# Claiborne and Millers Ferry Locks and Dams Fish Passage Study

## Appendix B-2: Environmental Laws and Coordination

# APPENDIX B-2: Environmental Laws and Coordination

Figure 3. Updated design of natural bypass structures at Claiborne and Millers Ferry L&D (USACE, Agency Decision Milestone Meeting, September 28, 2023).

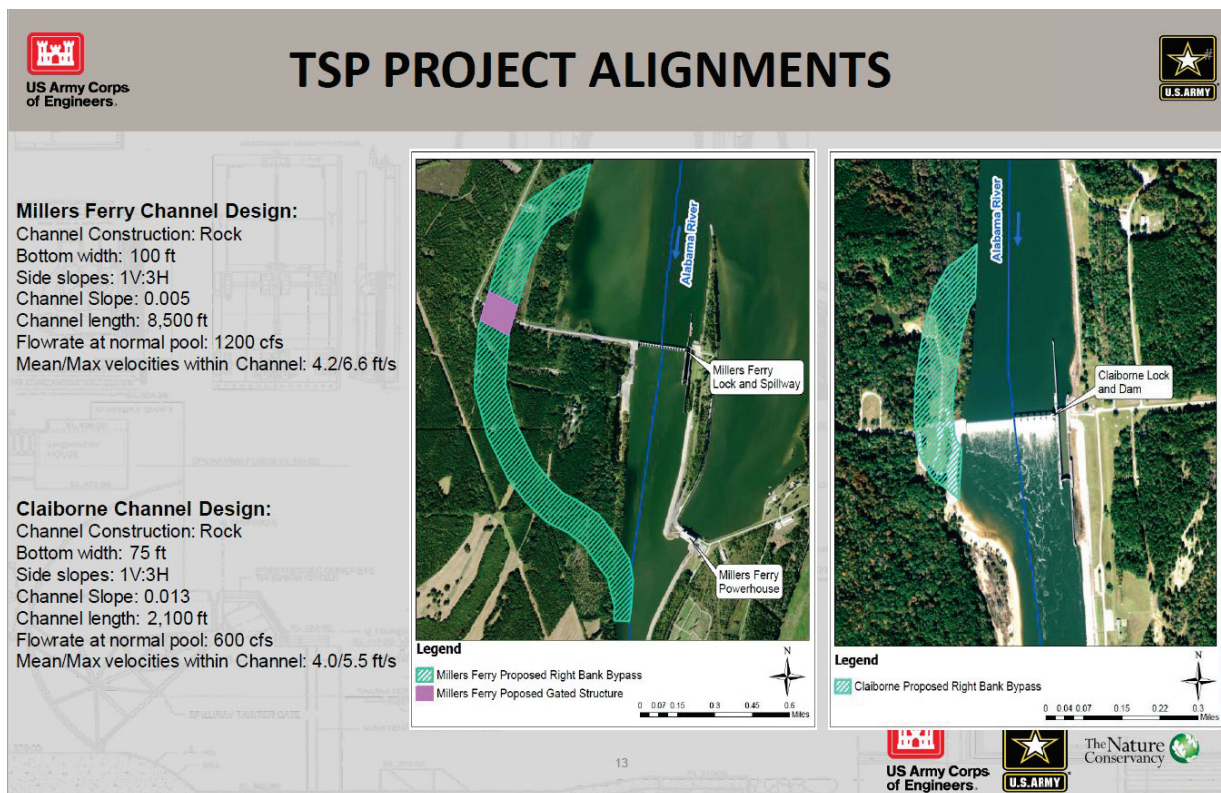
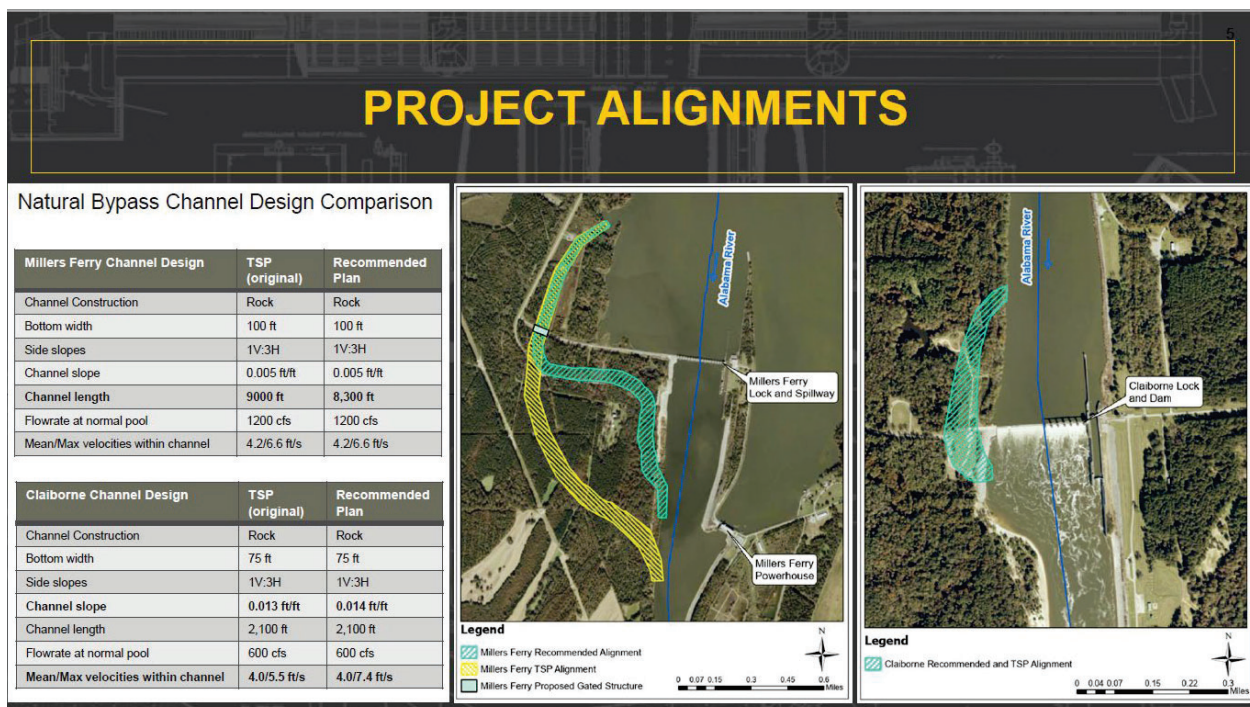
Channel design for Millers Ferry natural bypass includes rock channel construction, 100 ft bottom width, 1V:3H side slopes, 0.005 channel slope, 8,500 ft channel length, 1200 cfs flow rate at normal pool elevation, 4.2 ft/s mean velocity within channel, and 6.6 ft/s maximum velocity within channel (Figures 2 and 3). Channel design for Claiborne natural bypass includes rock channel construction, 75 ft bottom width, 1V:3H side slopes, 0.013 channel slope, 2,100 ft channel length, 600 cfs flow rate at normal pool elevation, 4.0 ft/s mean velocity within channel, and 5.5 ft/s maximum velocity within channel (Figures 2 and 3). The Corps has noted that additives for attraction to fish passage structures will be added to each structure; however, those additives have not been added to the overall structure design at the time of this report.

On September 28, 2023, the selected TSP was approved as the recommended plan at the Agency Decision Milestone meeting (Corps 2023b). The estimated cost for the Recommended Plan was initially \$161.2 million but has been updated to approximately \$184.3 million (Corps 2024b). The channel alignment at Claiborne L&D did not change; however, its design was altered to include stop logs to control flows during maintenance activities, additional erosion protection, and a sheet-pile cutoff wall between the bypass channel and the river (Figures 2, 3, and 4). The channel alignment at Millers Ferry L&D was altered to avoid private lands and is now fully on federally owned property (Figures 2, 3, and 5). In addition, the gate structure design now includes four slots that will be opened and closed as needed to maintain pool level during high and low flows (Corps 2023b).

Figure 7. A vehicular bridge will be included in construction of the natural bypass channel at Millers Ferry L&D. This bridge will provide public access to park and walk or fish from the shore of the Alabama River.

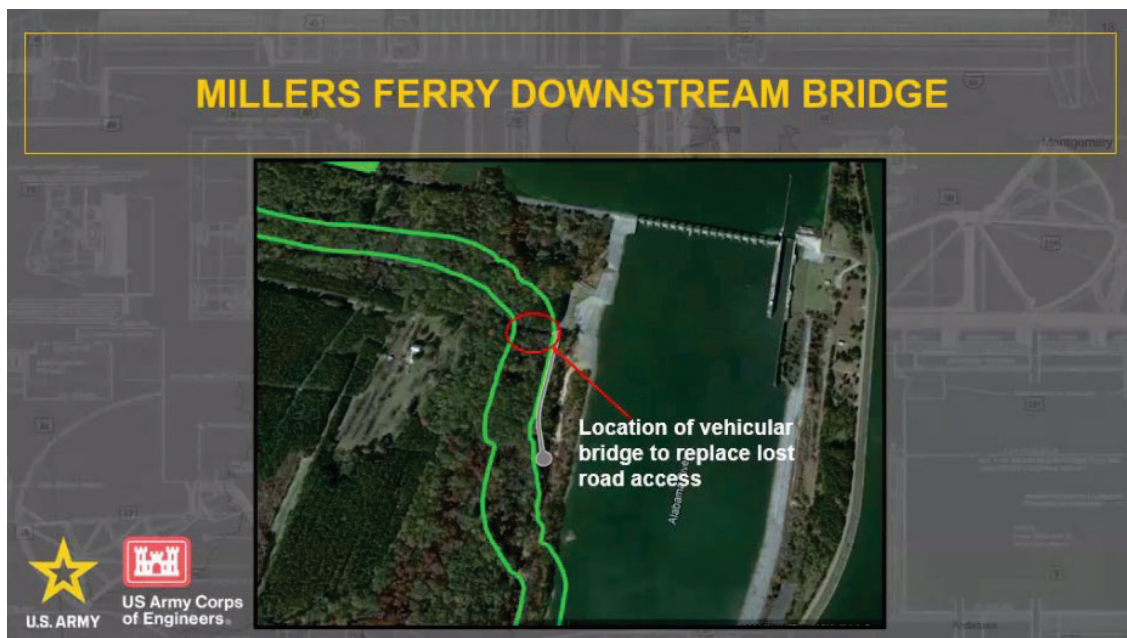
The Corps has determined that access to existing recreational areas would continue but would be rerouted at the dams. In addition, conversion of the existing duck ponds at Millers Ferry to a natural bypass channel would not significantly reduce recreation within the project area due to the continued access to the reservoir and surrounding fishing and hunting locations. A vehicular bridge at Millers Ferry L&D will provide public viewing and fishing access, and all public use amenities currently maintained at Claiborne L&D will be relocated and maintained after construction is completed (Figures 7 and 8).
